Request for Additional Information No. 110, Supplement 1

U. S. EPR Standard Design Certification

Docket No. 52-020

Application Section: FSAR Ch. 16

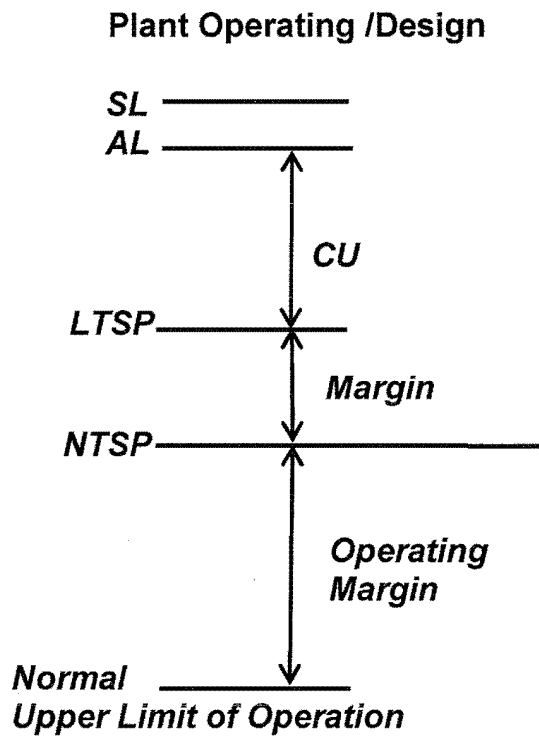
Correct as necessary the inequality signs associated with the limiting trip setpoints identified in Table 3.3.1-2.

In a few cases, the inequality sign associated with the proposed limiting trip setpoint (LTSP) was reversed. For example: the LTSP for reactor trip function 17, low steam generator level, is shown as \leq 20% narrow range, rather than \geq 20% narrow range; the LTSP for reactor trip function 19 (high containment pressure) does not include an inequality sign.

The setpoint relationships for a typical increasing process are shown below:

As shown, there is no margin between the AL and the LTSP. The LTSP is strictly the difference between the analytical limit and the instrument uncertainty. Therefore, the LTSP values in U.S. EPR FSAR Tier 2, Chapter 16, Technical Specifications Table 3.3.1-2 should not include the less than or equal to (\leq) or greater than or equal to (\geq) symbols. For example, if 100 percent is

the AL for a given trip function and the uncertainty is ± 4 percent, the LTSP would be 96 percent, not ≤ 96 percent. It could not be 95 percent when the uncertainty is only 4 percent since the LTSP cannot include margin. The actual NTSP would be ≤ 96 percent.

There are design limits in U.S. EPR FSAR Tier 2, Chapter 16, Technical Specifications Table 3.3.1-2 that are not explicitly supporting an AL, and the use of the \leq or \geq symbols would be appropriate. For example, the LTSP shown for the Control Room HVAC Reconfiguration to Recirculation Mode on High Intake Activity is less than or equal to three times background. Design calculations do not show that control room operator dose limits would be exceeded if this function actuated at a slightly higher value. Rather, the LTSP for the Control Room HVAC Reconfiguration to Recirculation Mode on High Intake Activity function is set high enough to avoid spurious operation but low enough to provide assurance that offsite dose consequences are maintained below acceptable limits. Therefore, symbols are specified for design limits. Column headings and the placement of relevant footnotes will be revised to reflect the distinction between values associated with LTSPs and design limits.
